Access Compliance Report

Public Rights-of-Way (Curb Ramps)

Intersection ID: 10038355	Main Street: SOUTH_BV	Cross Street: N/A	Location: NW
ADA ID: 2D8BC05E7DFD	Ramp Type: Perp	Initial Pass/Fail: Fail	Overall Compliance: No
Severity Score: 33.75			
Codes/Mitigation Info/Possible Solution		Field Measurements/Component Compliance

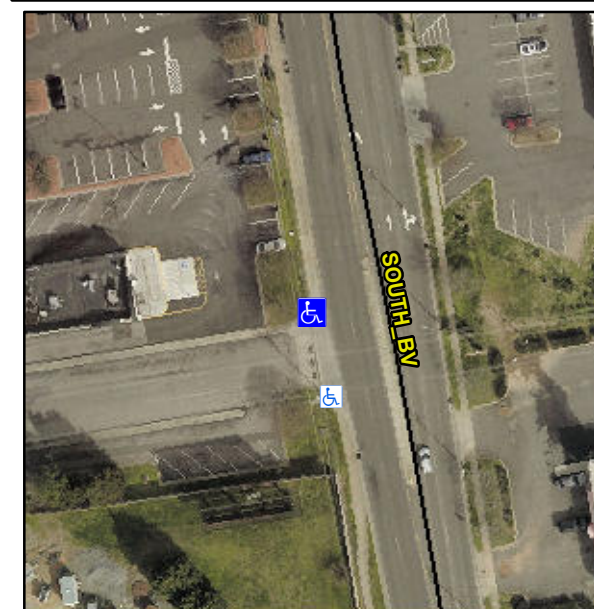
Not Found, R304.5.1, R304.2.2, R304.5.3

Compliance	Description	Data	Compliance	Description	Data
N/A	Ramp Length (in)	61.0	No	Ramp Slope (%)	9.9
No	Ramp Width (in)	46.5	No	Ramp XSlope (%)	6.5
N/A	Flare Type LT	N/A	N/A	Flare Type RT	N/A
N/A	Flare Slope LT (%)	N/A	N/A	Flare Slope RT (%)	N/A
N/A	Flare Traversable LT?	N/A	N/A	Flare Traversable RT?	N/A
N/A	Landing Length (in)	N/A	N/A	DWS Provided?	N/A
N/A	Landing Width (in)	N/A	N/A	DWS Contrast?	N/A
N/A	Landing Slope (%)	N/A	N/A	DWS Length (in)	N/A
N/A	Landing X Slope (%)	N/A	N/A	DWS Full Width?	N/A
N/A	Landing Curb? (Y/N)	N/A	N/A	DWS Offset (in)	N/A
N/A	Shared Landing?	N/A			
N/A	Gutter Ponding?	N/A	N/A	Gutter Slope (%)	N/A
N/A	Gutter Lip Ht (in)	N/A	N/A	Gutter X Slope (%)	N/A
N/A	Painted X Walk1?	No	N/A	Painted X Walk2?	N/A
	X Walk 1 Direction	To S		X Walk 2 Direction	N/A
N/A	X Walk 1 Width (in)	N/A	N/A	X Walk 2 Width (in)	N/A
	X Walk 1 Slope (%)	4.6		X Walk 2 Slope (%)	N/A
	X Walk 1 X Slope (%)	10.5		X Walk 2 X Slope (%)	N/A

Remove & Replace Entire Ramp.
